# HISTORIC AND DESIGN REVIEW COMMISSION

December 06, 2023

**HDRC CASE NO:** 2023-257  
**ADDRESS:** 114 DEWBERRY ST  
**LEGAL DESCRIPTION:** NCB 6461 (MISTLETOE ADDITION SUBDIVISION), BLOCK 1 LOT 57  
**ZONING:** R-4, H  
**CITY COUNCIL DIST.:** 1  
**DISTRICT:** River Road Historic District  
**APPLICANT:** Jim Tafoya/Brio Builders  
**OWNER:** Daniel Pina/PINA DANIEL & STEPHANIE  
**TYPE OF WORK:** New construction of a two-story residence  
**APPLICATION RECEIVED:** July 20, 2023  
**60-DAY REVIEW:** September 18, 2023 (Requested postponement by applicant to December 6, 2023)  
**CASE MANAGER:** Jessica Anderson  
**REQUEST:**

The applicant requests a Certificate of Appropriateness for approval to construct a two-story residential structure on the vacant lot at 114 Dewberry.

FRONT - WEST ELEVATION

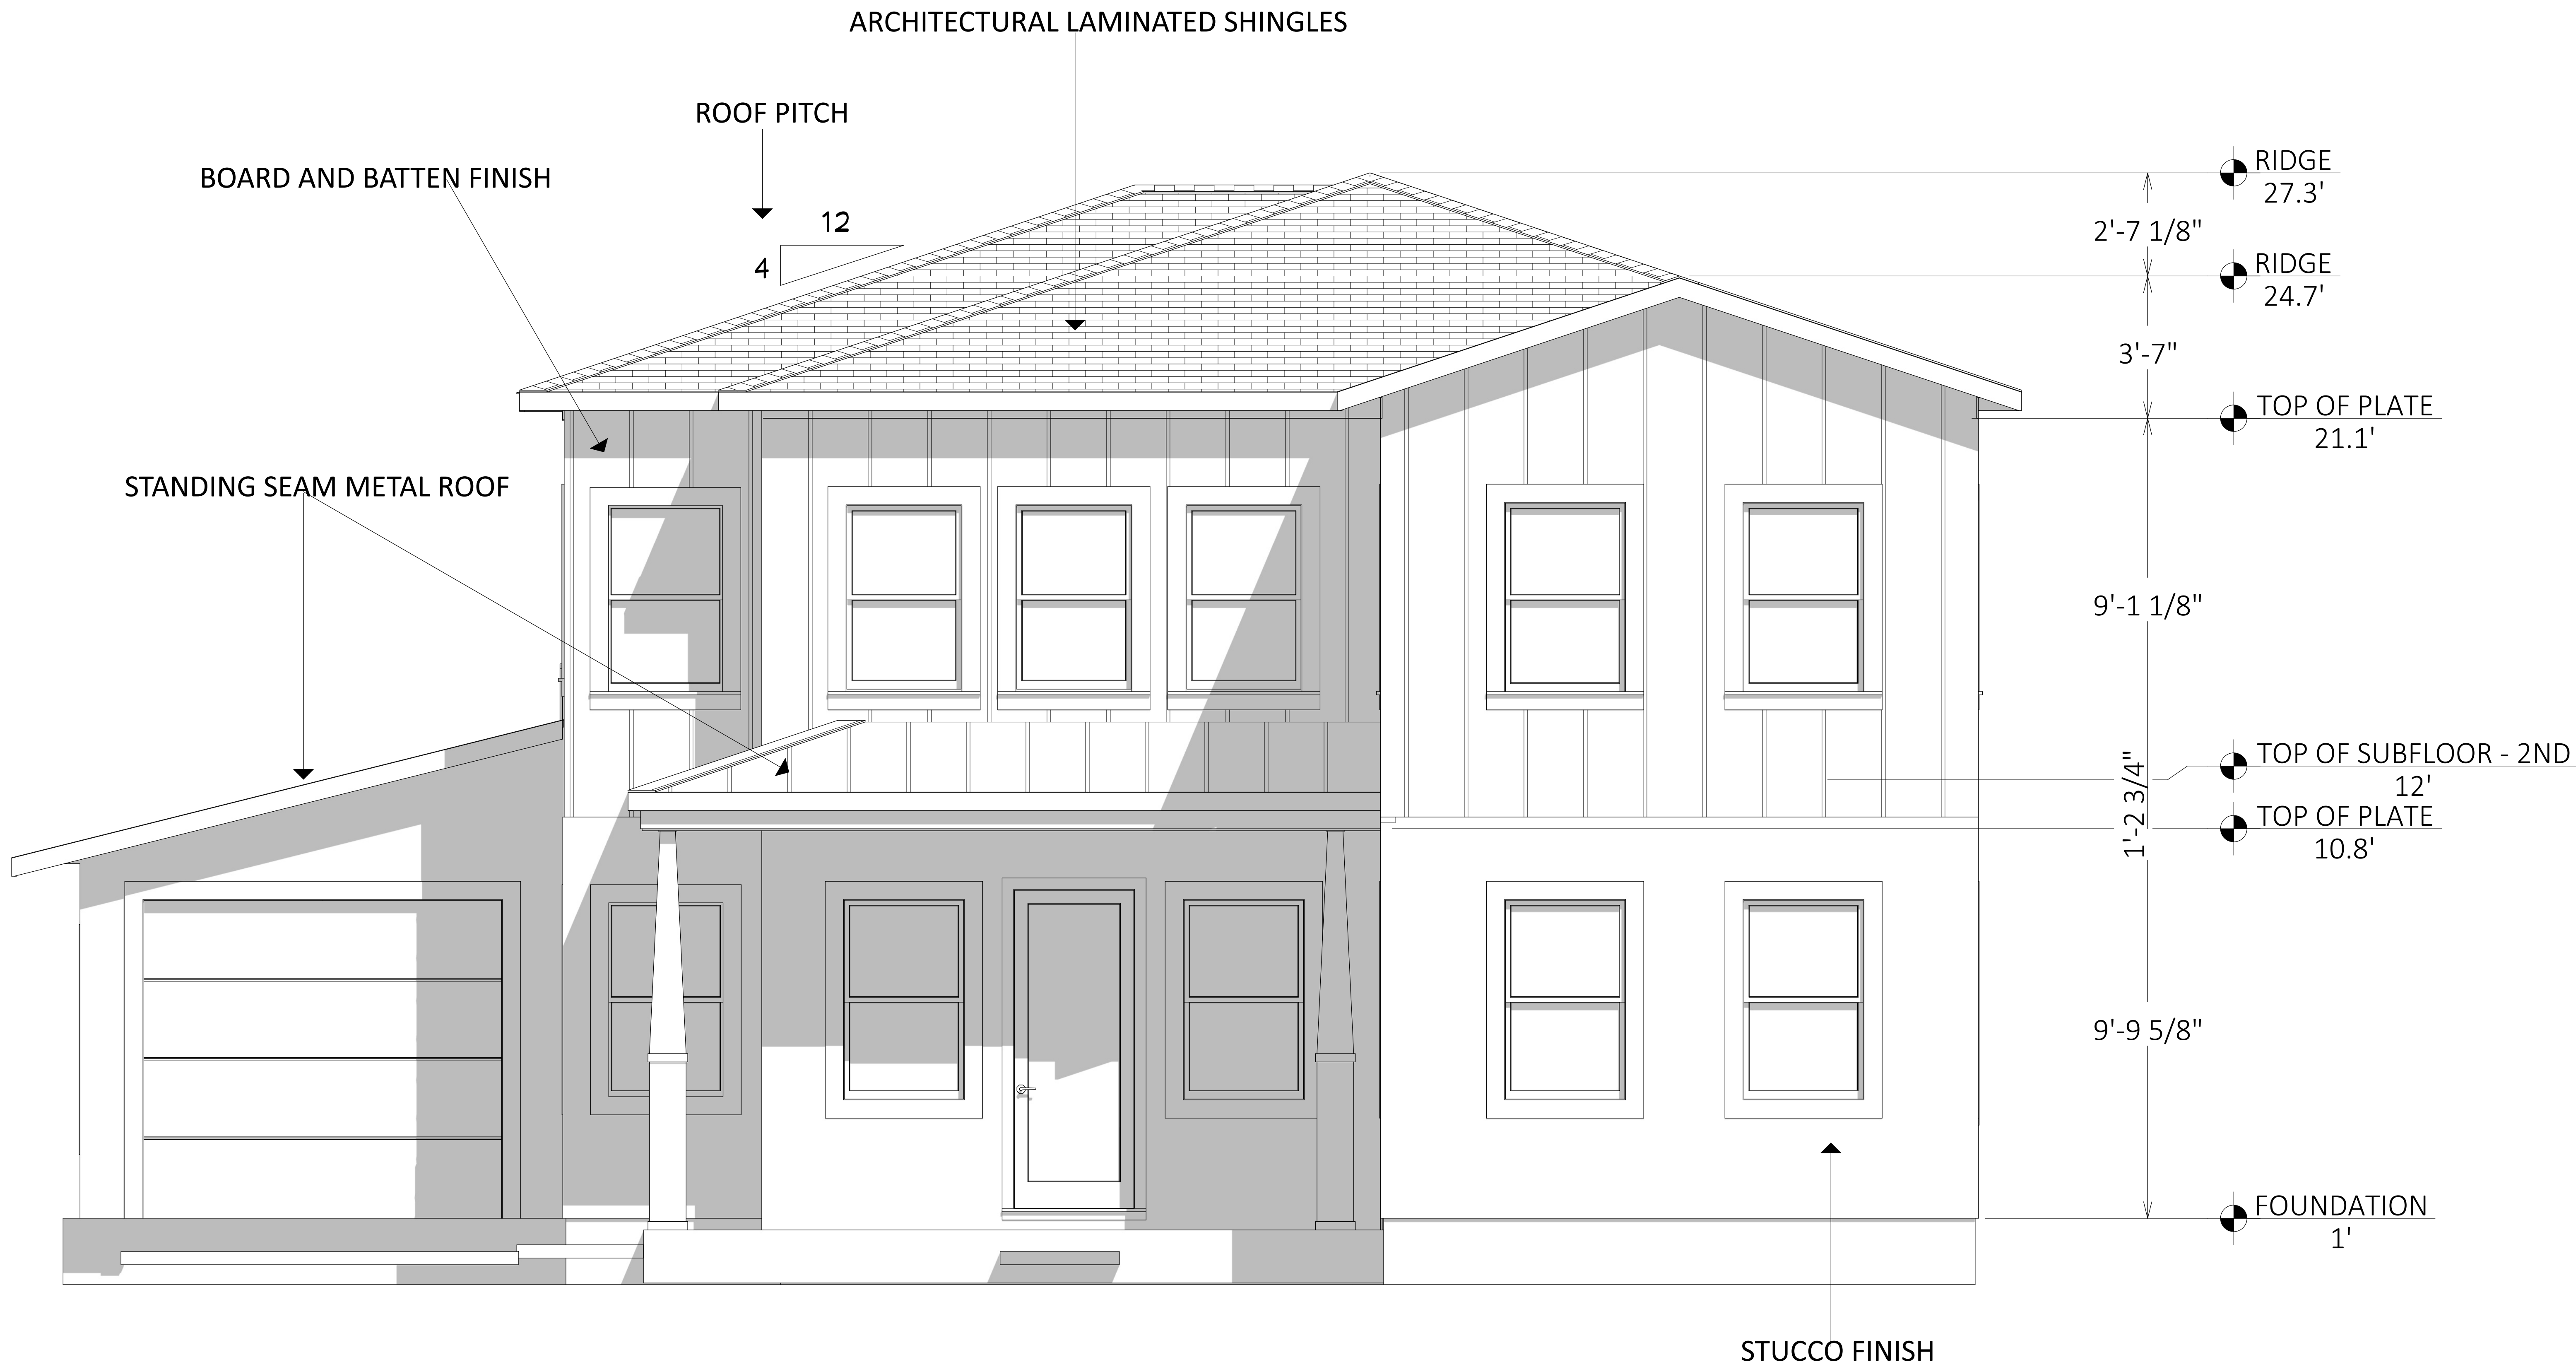
Fetzer: I would agree with Commissioner Mazuca. I think this is a much better, more traditional entry into the home with the location of the door rather than tucked around the corner, but the front elevation is composed around the front door and I think that's a much better design. I'm a little concerned about the size of the rear balcony. Based on your plan and your elevations, it's about 11'6" deep, which is almost doubling the size of your living room. And I'm not sure how that falls within the 20' setback line that development services would consider. I'm not sure the balcony would be considered complying with the 20' setback.

Fetzer: There are parts of the drawing on the left that get closer to addressing staff's concerns about the front porch. I think the one on the right, the hipped roof on the main body of the house, that is more successful than the big gable

Fetzer: If the hipped roof over the entrance became a gable roof, similar to the drawing on the right. And behind that, instead of the gable, do a hipped roof like on the last submitted design. With the gable, it's a much stronger entry element, especially with the center door, that starts to address some of the more traditional massing of the more historic houses. I would keep the one-over-one windows on the far right on the first floor.

Fetzer: We're just two of the commissioners, and there are more, and you need to talk to your client about moving the front door. If they're set on the floor plan, then you just need to make your case. It's only a suggestion, but if it doesn't work for your client, I can understand that. Don't feel that it's a mandate that you move the door. It's a suggestion to address the entry massing of the building.

10' PRIVATE SAN SWR ESMT.

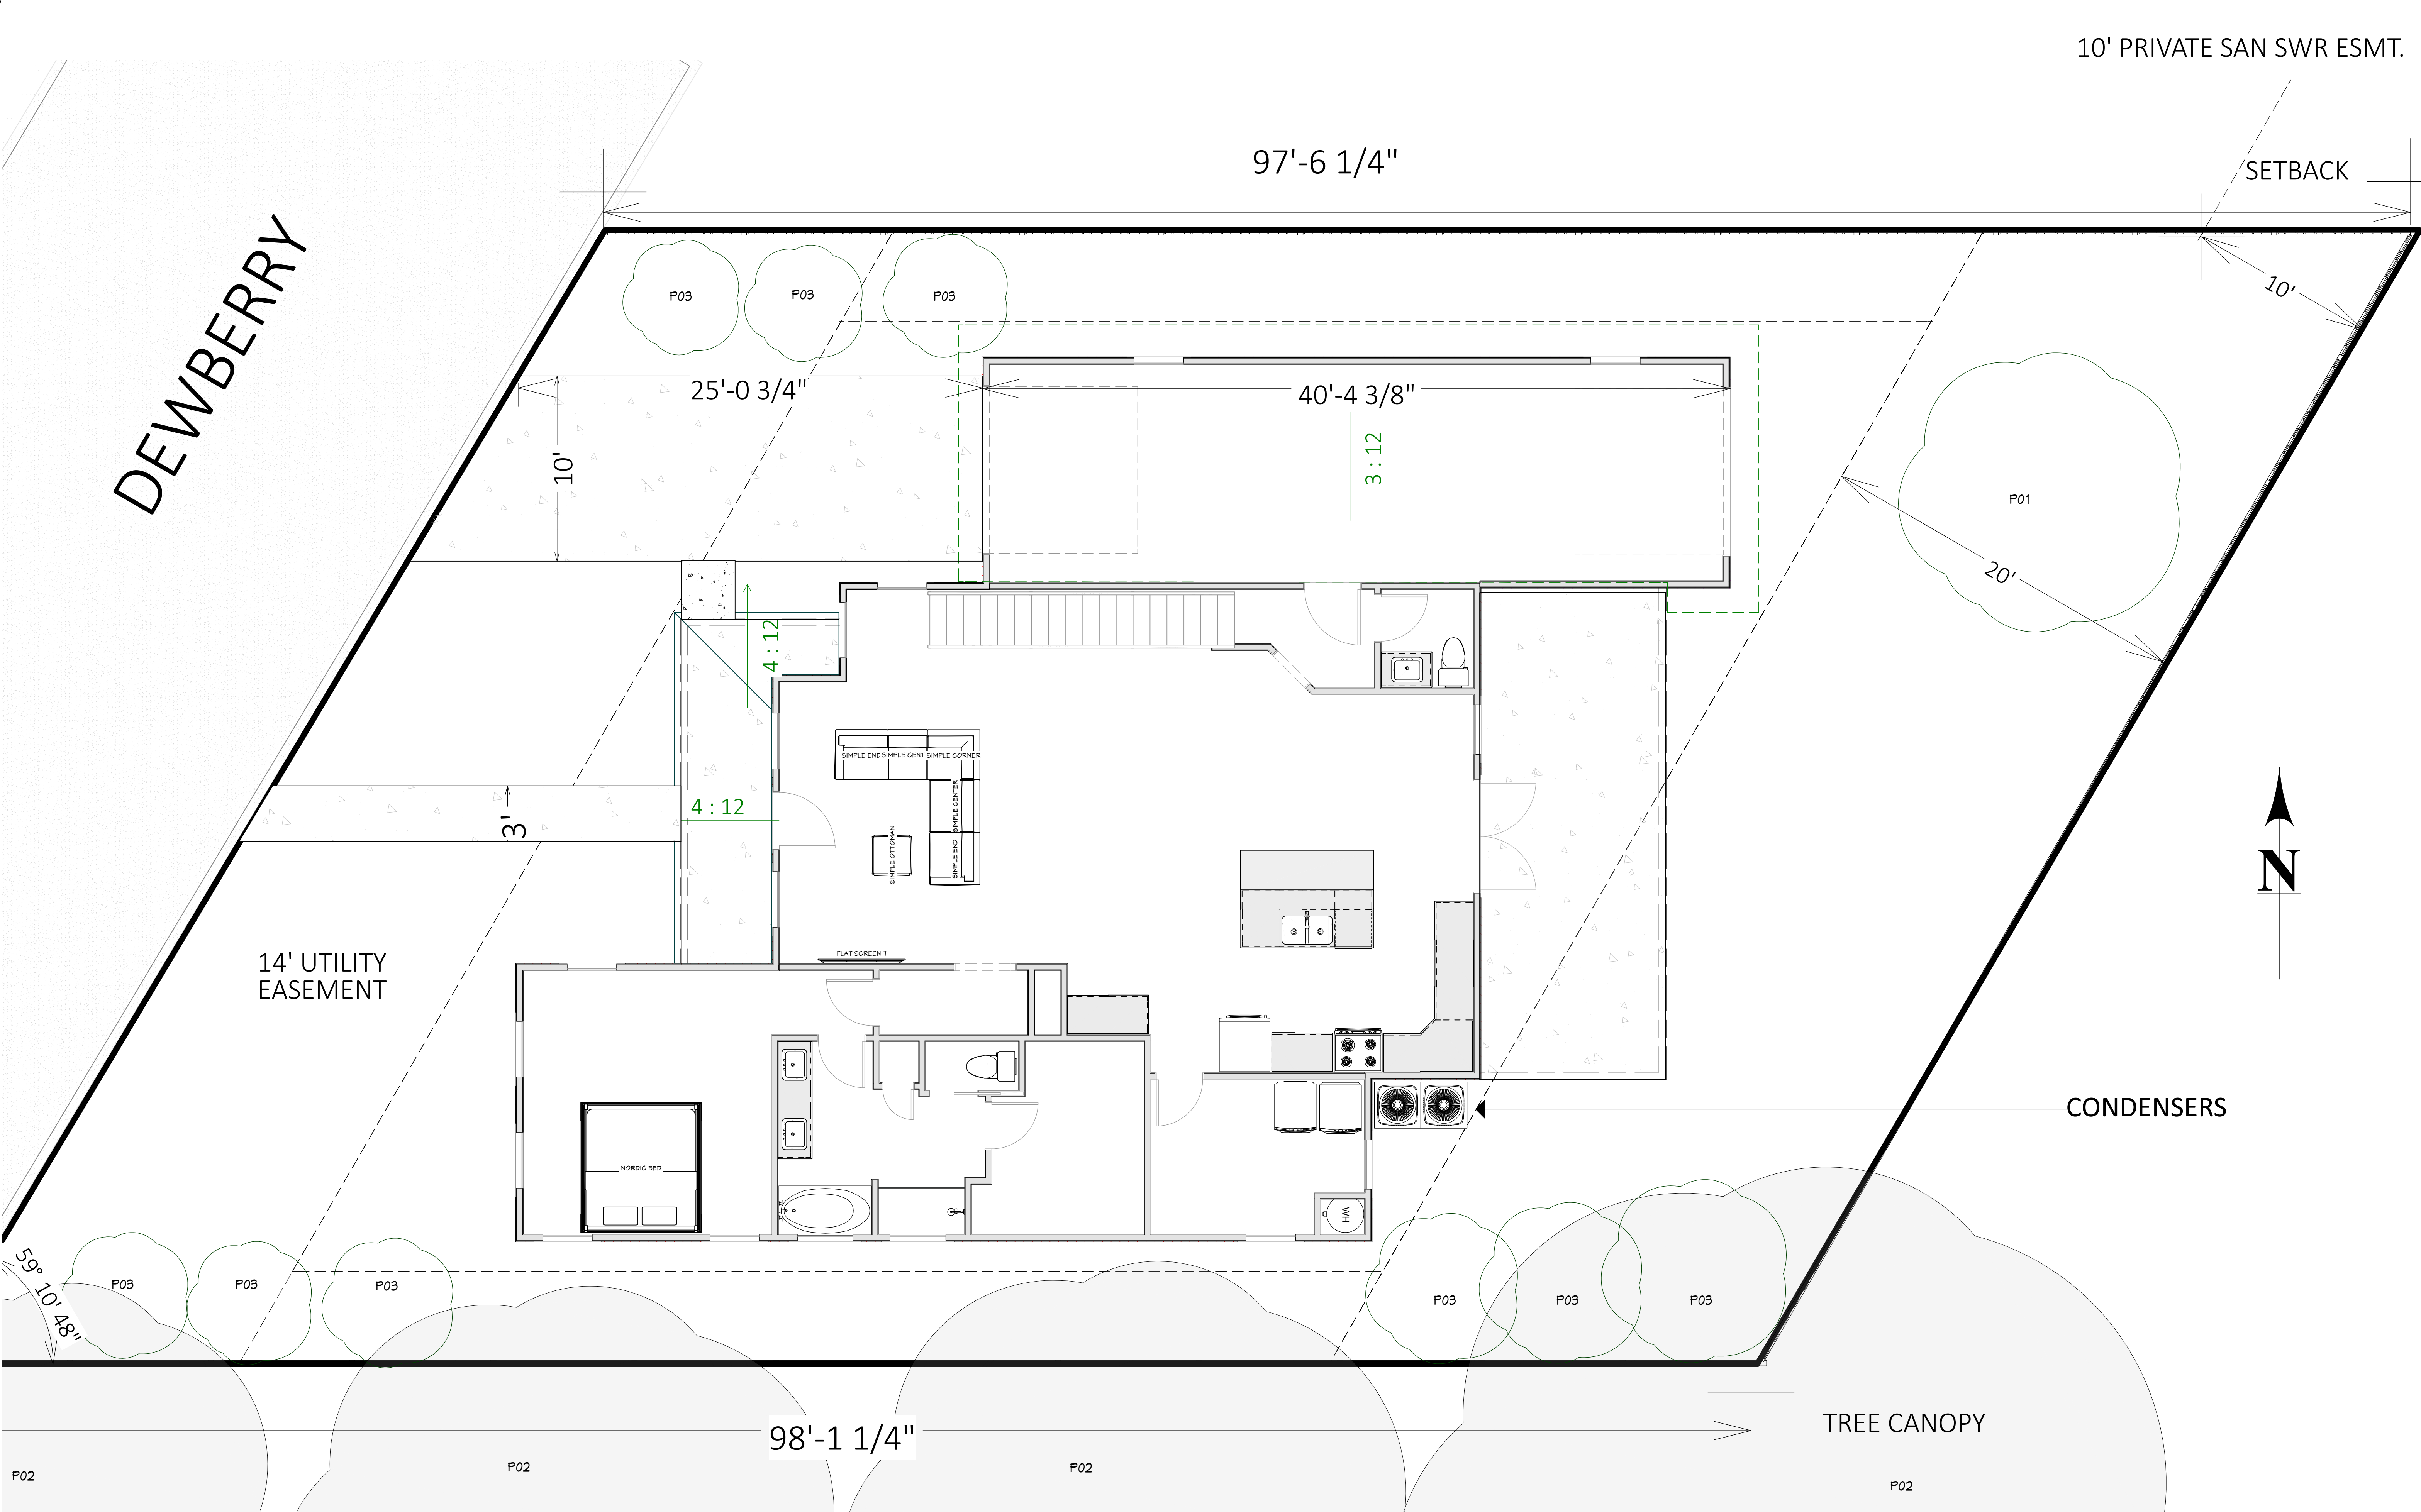
Fetzer: Based on the porch and 20' setback, both encroach. Need to confirm with DSD whether a balcony under the roofline of the main house can extend into that setback. The setback is probably not just on the ground plane, it's probably vertically too.

Fetzer: Get with DSD about what's allowable behind that 20' setback, whether you'd need to ask for a variance. Something that would be helpful on this plan is a distance from the southeast corner of the porch perpendicular to the rear property line. Is that also 10', or is it something else?

Fetzer: Would it be possible to add a diagonal line at that 20' setback on the site plan?

Fetzer: Update site plan to show changes (sheet 1-13)
